Our File: **A01-24**

APPLICATION FOR MINOR VARIANCE
SUPPLEMENTARY REPORT

REPORT NUMBER: CP 2024-187

OWNER: Greg and Dawn Zehr
657173 15th Line, Tavistock, ON N0B 2R0

Plate 4: Applicants' Sketch - Elevations

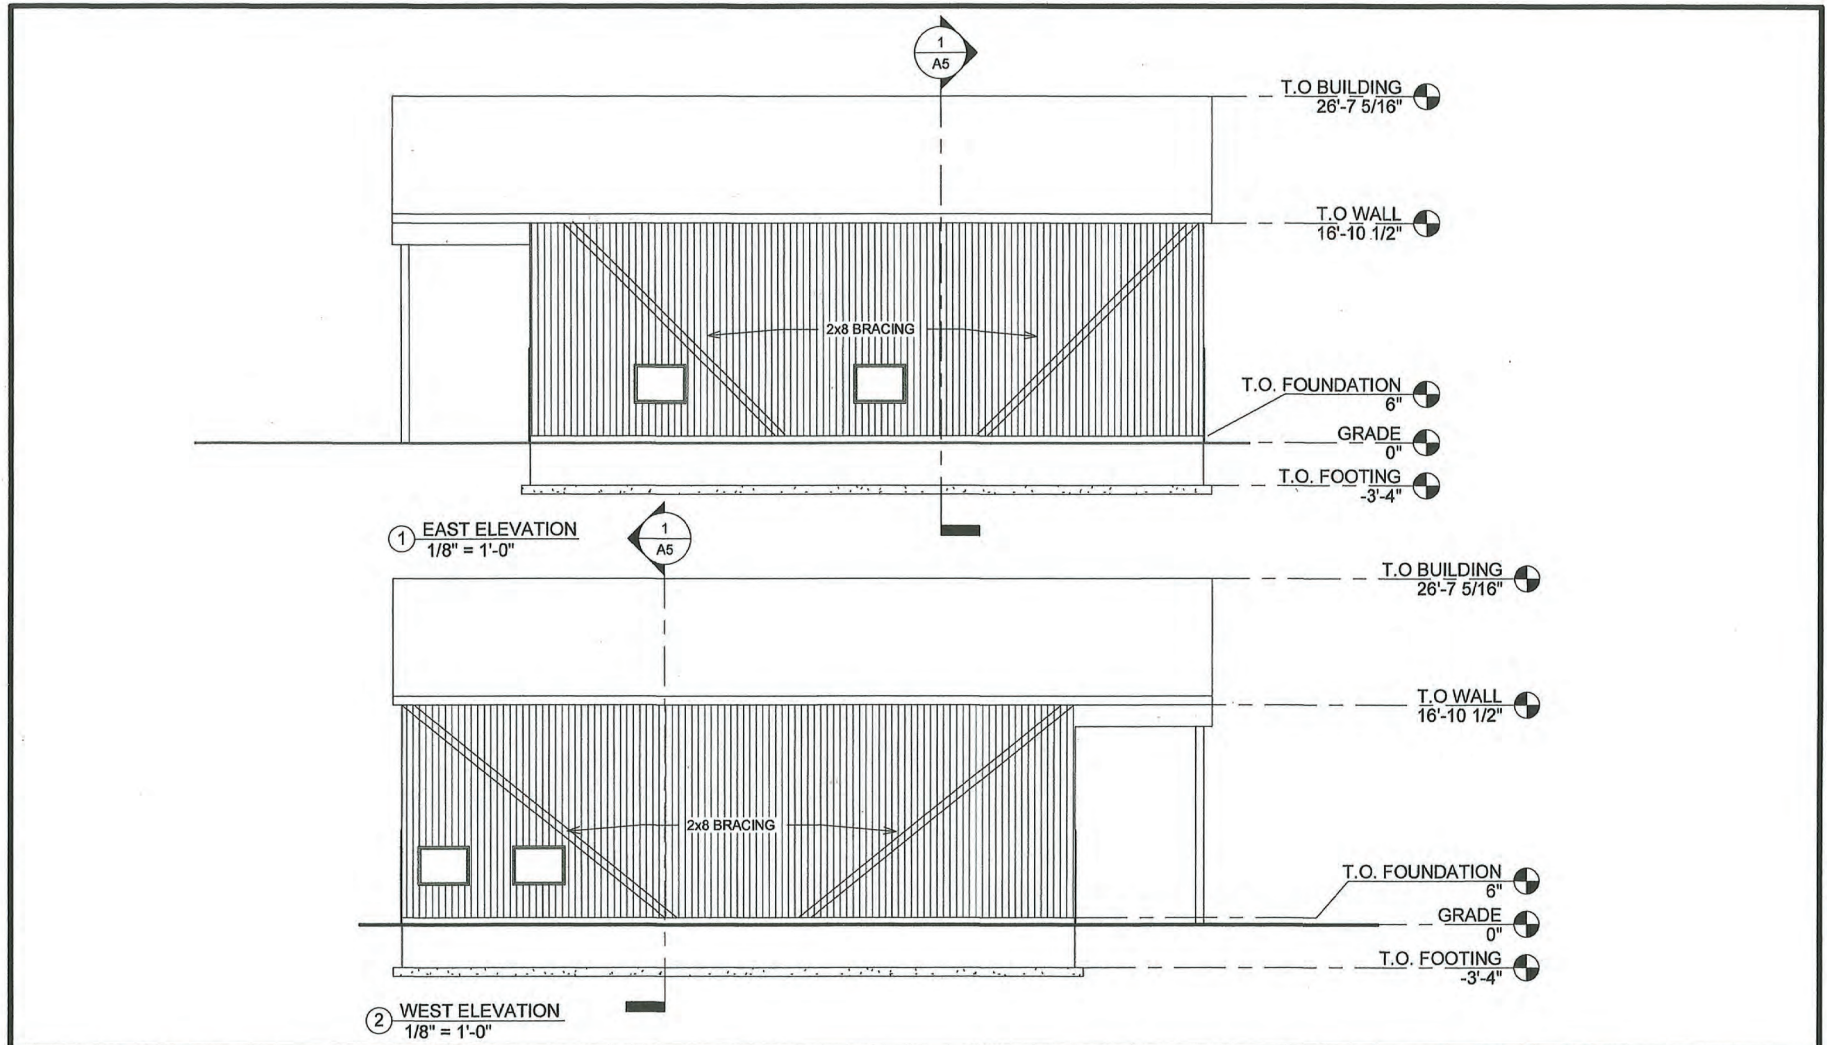
Generally, staff are of the opinion that the construction of a building accessory to a residential use is in keeping with the Agricultural Reserve designation policies of the Official Plan, however, Planning staff are of the opinion that the size and scale of the proposed detached accessory structure is larger than what might typically be considered appropriate for the principal residential use of the lands. As such, it is the opinion of the Community Planning Office that the proposal does not maintain the intent of the Official Plan in terms of residential accessory buildings within the Agricultural Reserve designation.

The coverage and height standards contained in the Township's Zoning By-law have been adopted by Township Council and are considered to be both reasonable and acceptable for buildings and structures accessory to a residential use. In this case, the gross floor area for the proposed accessory building appears to represent more than 2.5 times the size of the existing single detached dwelling. When accounting for the existing accessory building's size, the total gross floor area for accessory buildings would represent more than 3 times the size of the single detached dwelling. In the opinion of staff, the size of the proposed accessory building would mean that the building would not be considered secondary to the residential use.

Planning staff are of the opinion that an increase of this size and height goes beyond the provisions of the Zoning By-law such that it is not considered to be appropriate for the residential use needs of the lands and as such the proposal is not in-keeping with the intent of the Zoning By-law.

That the Township of East Zorra-Tavistock Committee of Adjustment **not approve** Application File A01-24, submitted by Daryl Bender on behalf of Greg and Dawn Zehr for lands described as Part Lot 36, Concession 14 (East Zorra) in the Township of East Zorra-Tavistock as it relates to:

① SOUTH ELEVATION
1/8" = 1'-0"

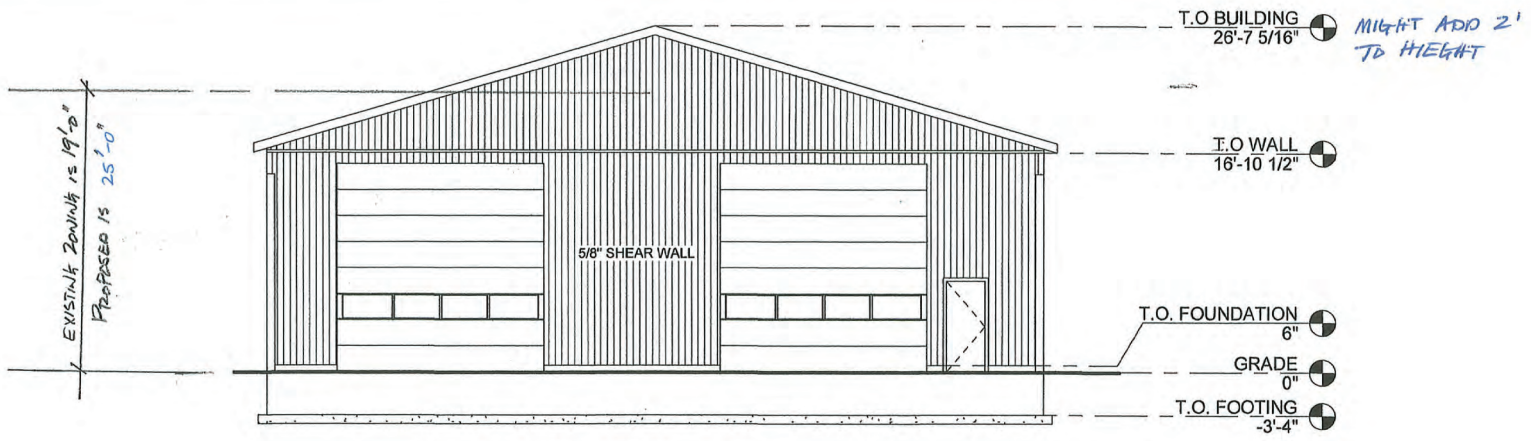
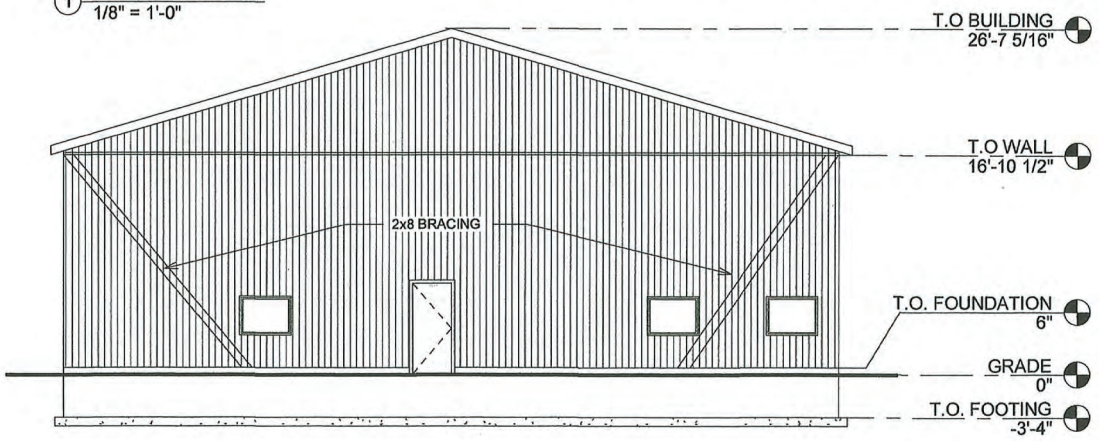
*MIGHT ADD 2'
TO HEIGHT*
